Application No. 09/052325
Reply to Office Action of November 30, 2005

Docket No.: E0295.70266US00

In the Drawings

REMARKS

FIG 1
(PRIOR ART)

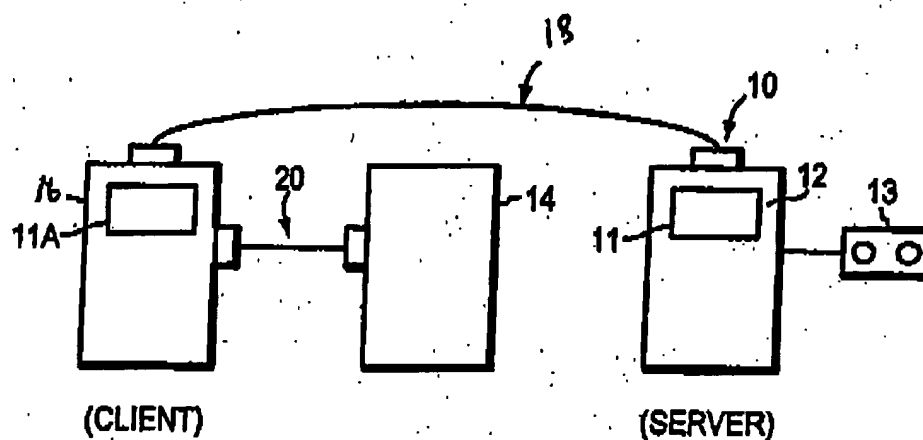
Figure 1 was amended by inserting an annotation "(Prior Art)".

FIG. 2

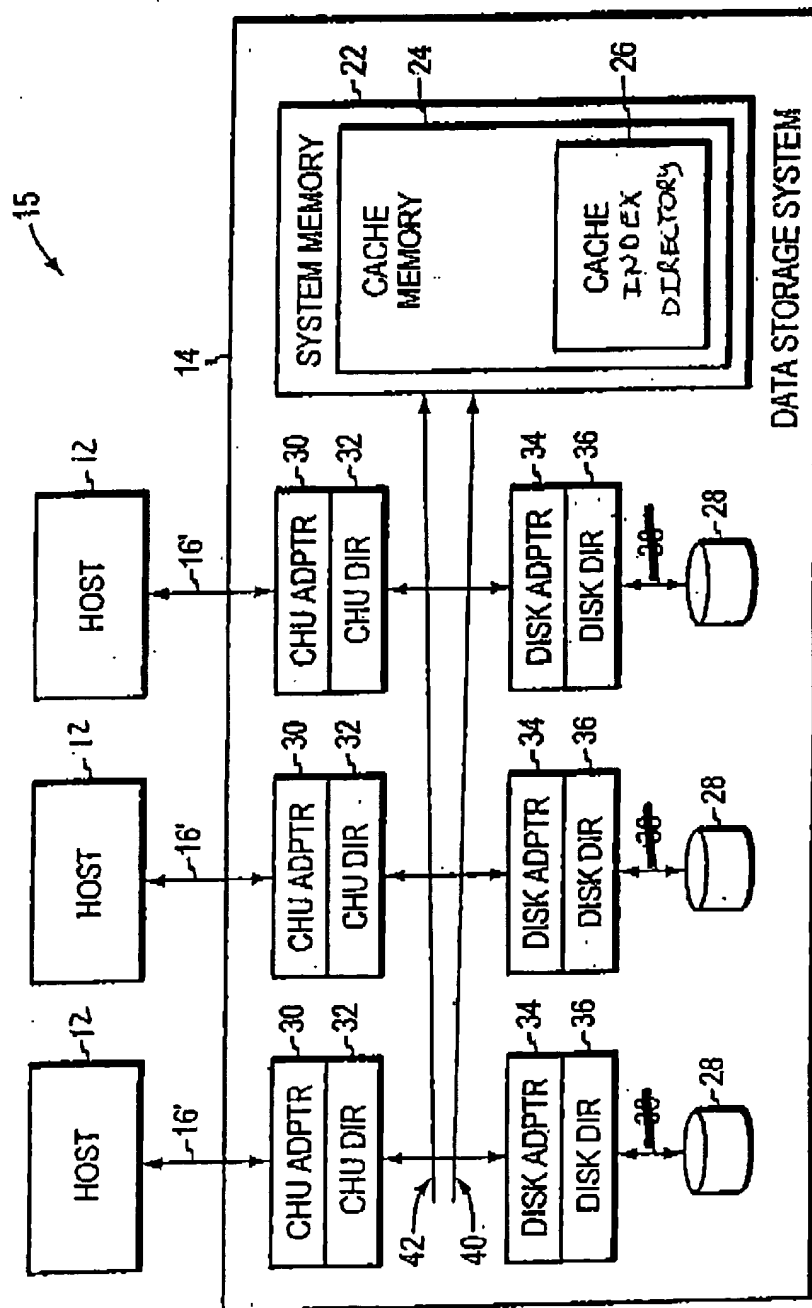
Figure 2 was amended by taking out reference number 38 and lead line in three places.

The Examiner objected to the specification because element 38 in FIG. 2 is not described in the specification. Applicants have submitted a replacement sheet amending FIG. 2 to delete reference numeral 38. Though a connection between disk directors 36 and disk device arrays 28 is described in the specification, for example, at page 13, lines 1-7, the connection is not referred to by name or by reference number 38. Accordingly, the amended drawing is now consistent with the specification.
